ENGINEERING CHANGE NOTICE

1. ECN 666067

6. Project Title/No./Work Order No.	7. Bldg./Sys./Fac. No.	8. Approval Designator	
		Interim Stabilization, Essential Drawings, 113340	241-G/200-GEN	N/A

RPP-7567, REPORT ON NEW PUMPING SYSTEM SOFTWARE ON PUMPING
INSTRUMENTATION AND CONTROL SKIDS

LAD 5 - --- Total Rungs in File = 83

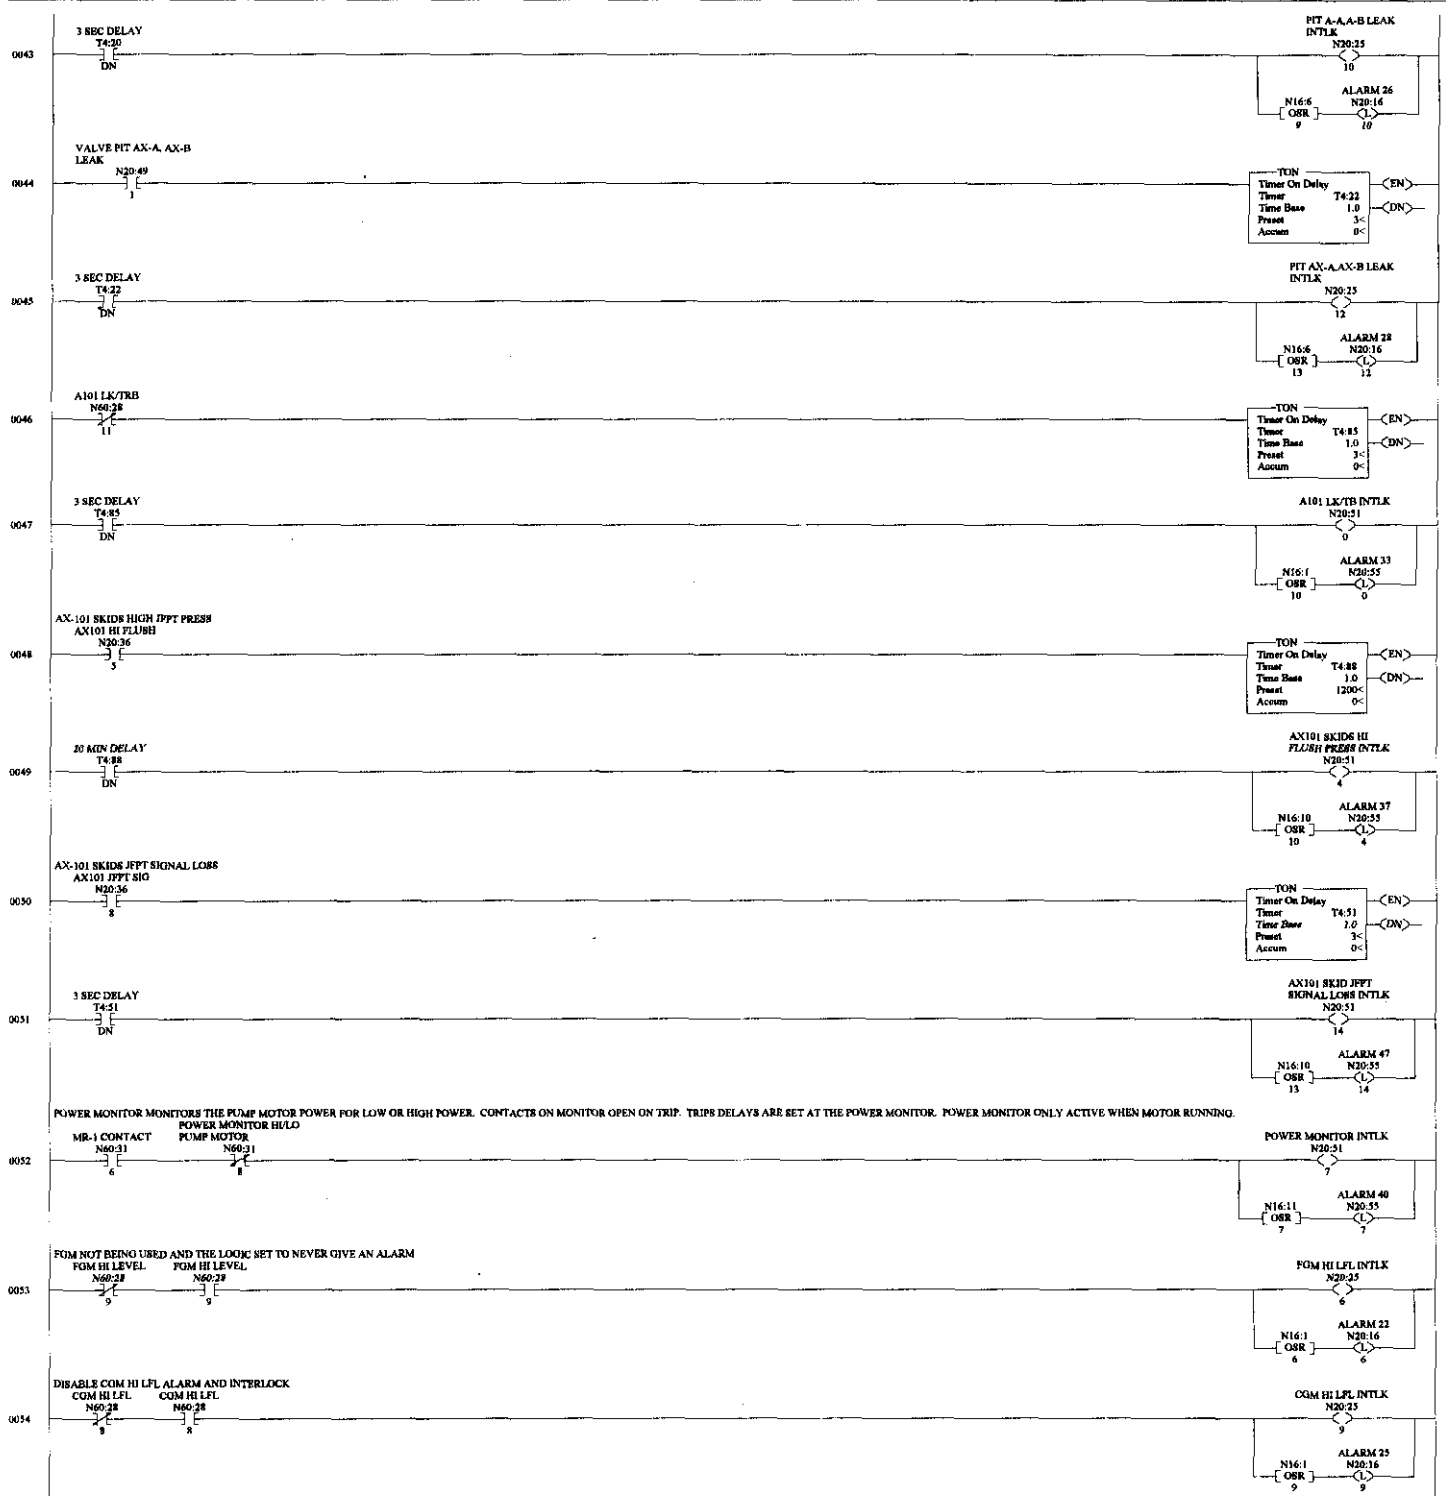
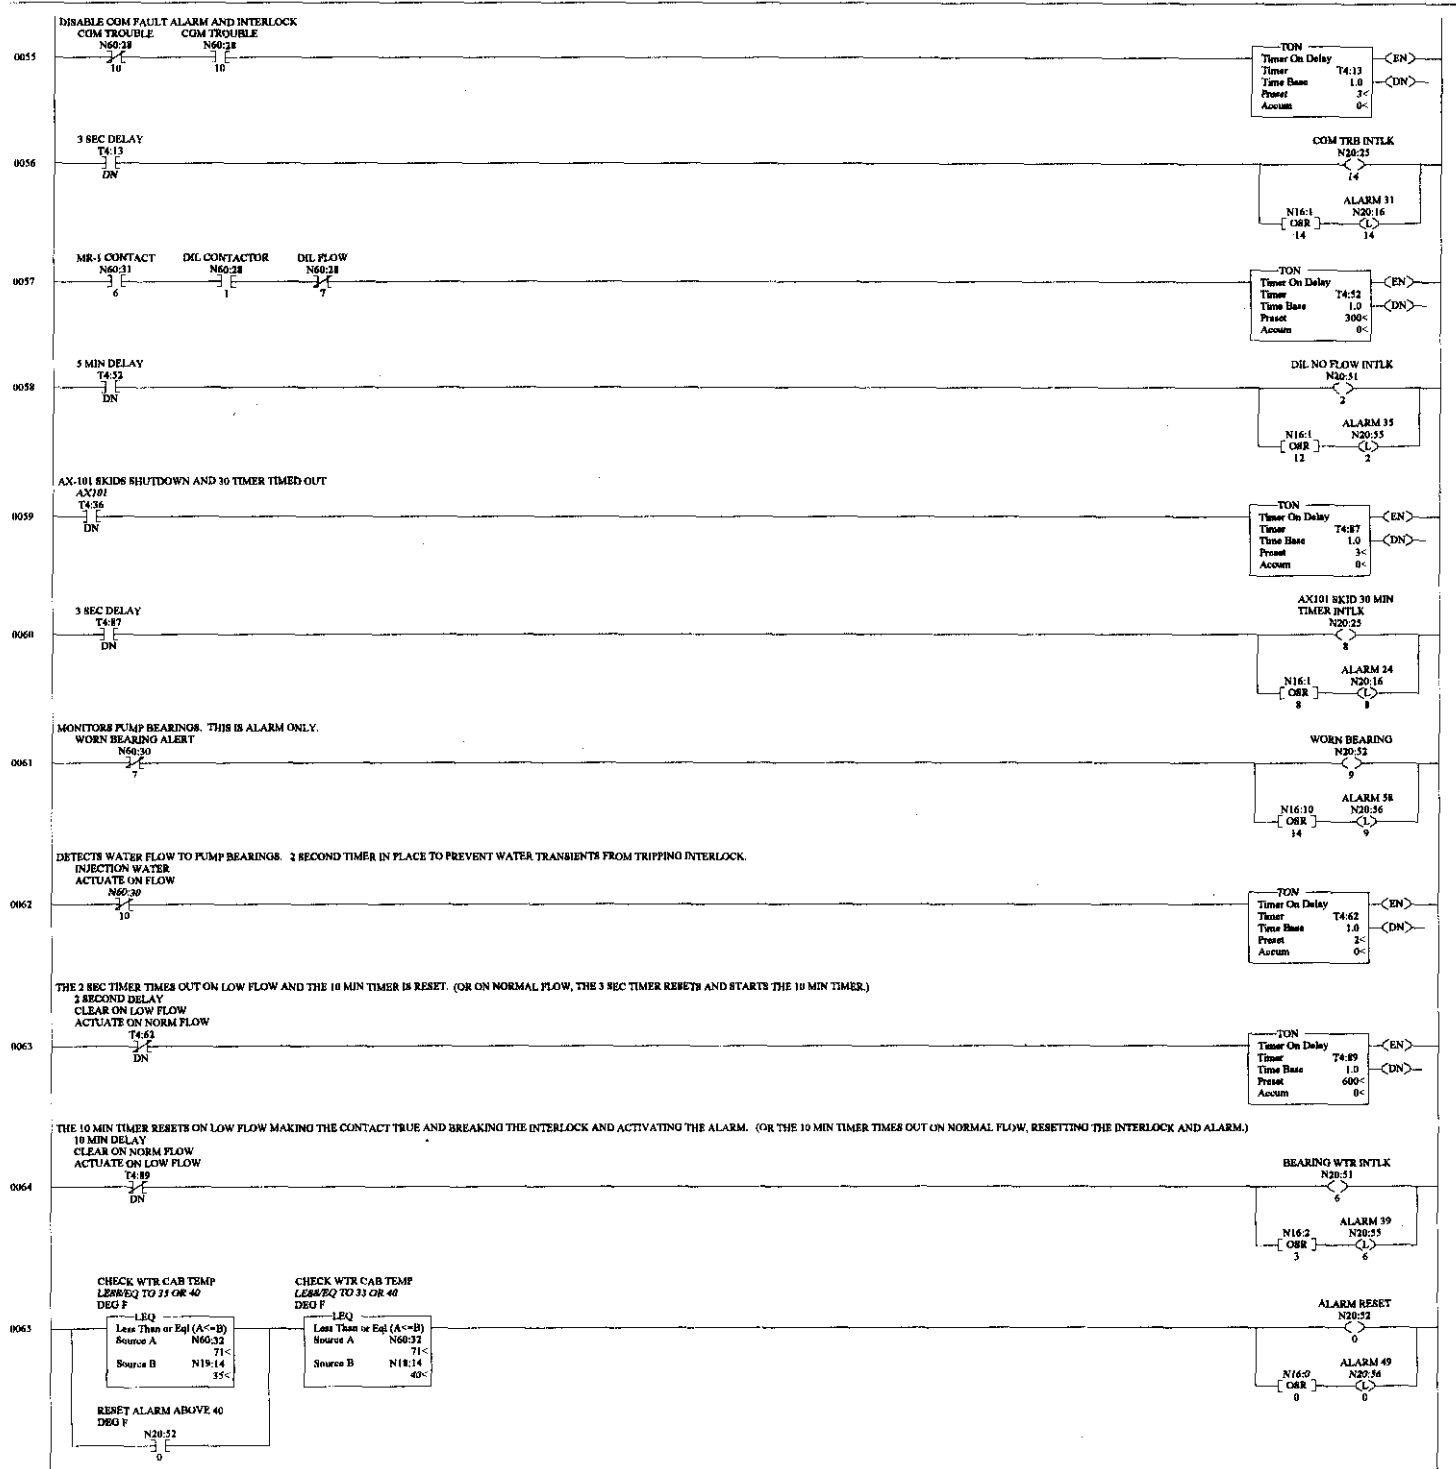
- 6.5 Ladder 5: This ladder is the alarm activation and interlocks for the saltwell pump motor. The following changes were made.
 - 6.5.1 The trip point in rung 0 is changed from 15 psig to 30 psig. This is due to the additional pressure from the injection water pump attached to the system.

- 6.5.2 Rung 6 has a bump relay contact added that is **TRUE** when the bump sequence is not active or during the bump sequence when the pump is running for the 1 second time period. The contact is **FALSE** during the 10-second shut-off time during the bump sequence to prevent a pump trouble alarm and interlock break from occurring.

- 6.5.3 Rung 17 has the pump low temperature logic portion is changed from the pump bearing thermocouple to the pump assembly thermocouple since the pump bearing temperature no longer exists. Alarm 8 will now activate upon jumper heat trace high temperature or low pump piping temperature.

- 6.5.4 Rung 22 has a bump permissive contact inserted that is **TRUE** when the bump sequence is inactive. The contact is **FALSE** when the bump sequence is active to prevent the shutdown alarm and horn during the 10 second off time during the bump sequence. A time delay contact is used to prevent a false alarm during the switch from bump to normal start.

- 6.5.5 Rungs 24 and 25 are deleted since the recirculation pressure transducer no longer exists. Two new rungs 24 and 25 are inserted for the motor winding temperature high shutdown and warning. Rung 24 monitors the winding temperature and will break the interlock and activate alarm 14 when the temperature is 390 degrees F or higher. The interlock will remake and alarm clear upon the temperature dropping below 370 degrees F. The logic functions as follows: when the temperature is 390 degrees F or higher, the two GEQ become **TRUE** thus making the interlock and alarm outputs **TRUE**. The reset contact N20:52/10 becomes **TRUE**. When the temperature drops below 390 degrees, the first GEQ becomes **FALSE**, but the rung remains **TRUE** due to the reset contact. When the temperature drops below 370 degrees, then the second GEQ becomes **FALSE**, thus making the alarm, interlock and reset elements in the rung **FALSE**. New rung 25 functions in the same manner except the true setting is at 380 degrees F, but the reset point is the same at 370 degrees. There is no interlock associated with rung 25, only alarm 59. This rung is to provide a warning to the operator that the motor temperature is approaching the high shutdown temperature.

- 6.5.6 Rungs 56 through 57 are deleted. The recirculation pressure and signal loss are no longer used. The motor bearing temperature is replaced with the motor winding high temperature in new rungs 24 and 25 described above. A new rung 56 is added for the power monitor interlock and alarm. The series high and low power contacts on the power monitor are monitored by address N60:31/8. When either of the power monitor contacts open, the N60:31/8 contact in rung 56 becomes **TRUE**. If the pump motor is running, then when the power monitor contact is true, the interlock and alarm outputs become **TRUE** thus breaking the motor interlock and activating alarm 40. The power monitor has internal circuitry for delays for startup power changes. The interlock and alarm clear upon pump shutdown due to both the motor and power monitor contacts resetting making the rung **FALSE**.
